Sandy Urban Renewal Board Meeting

From David Snider, Economic Development Manager
Covered Structure Grant Application: Sandy Family Restaurant /

SUBJECT: Ria's Bar

CITY OF SANDY - SHADE COVER STRUCTURE
MOUNTAIN VIEW CONTRACTING
39024 PROCTOR BLVD,
SANDY, OR 97055

SHEET TITLE: RIGHT ELEVATION	
SHEET NO.:	
A-1.2

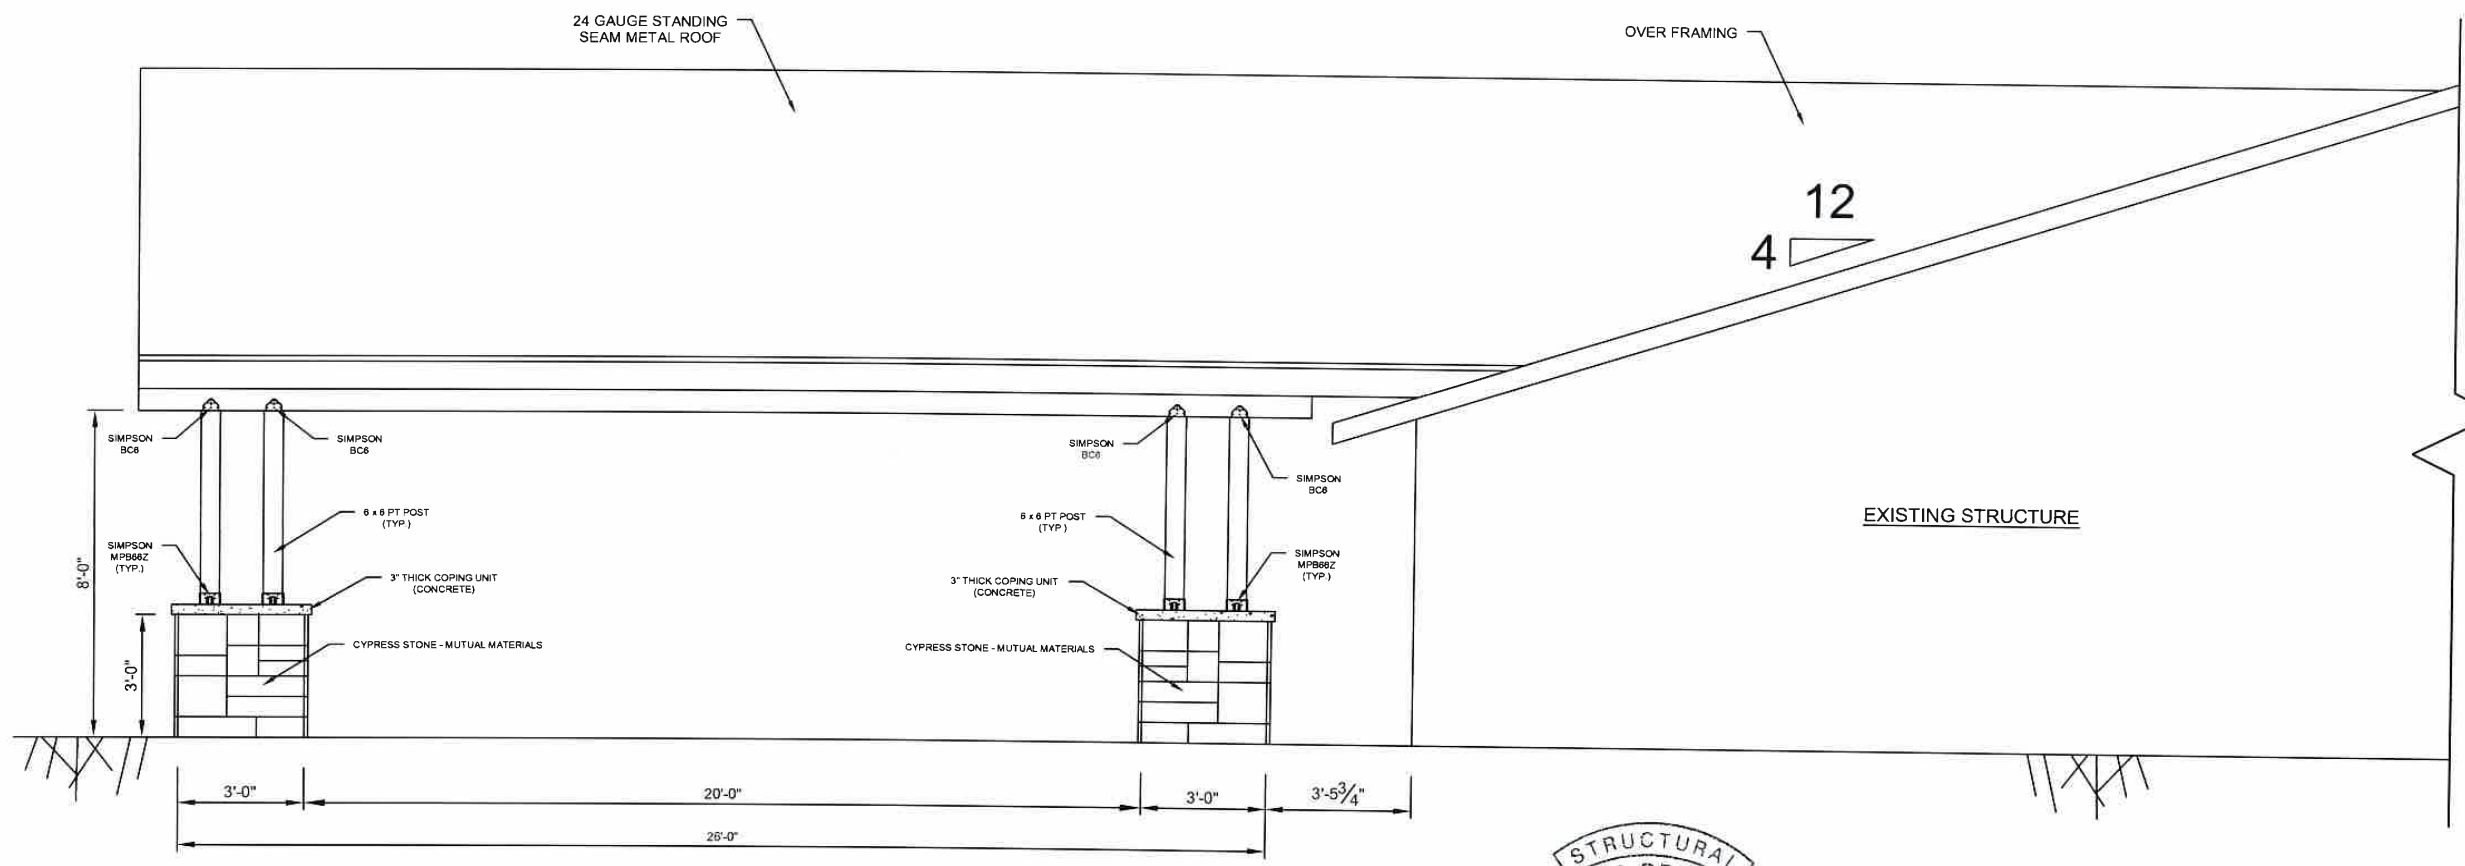
On February 1, the owner of Ria's Bar and our design contractor proposed a modification to the plan set adding a tie back for the covered structure to the primary building. This modification is estimated to cost \$13,400 by the contractor providing the winning bid. With this modification, the overall project cost is anticipated to cost \$70,525, with an urban renewal commitment of 80 percent, or \$56,420. See the proposed plan set for this proposed structure modification, which is also attached.

Description	Total
<p>The following is a change order to estimate #1482 for Ria's Sandy Family Restaurant located at: 39024 Proctor Blvd, in Sandy</p> <ul style="list-style-type: none"> -Tie back timber frame to existing building as an over frame. -Sheet both sides of timber frame with rough sawn plywood, facing attic. -Frame with dimensional lumber per plan. -Sheet roof with 1/2" OSB. -Install 2 valleys -Roof with standing seam metal roofing from Metallion, to match existing. 	13,425.00
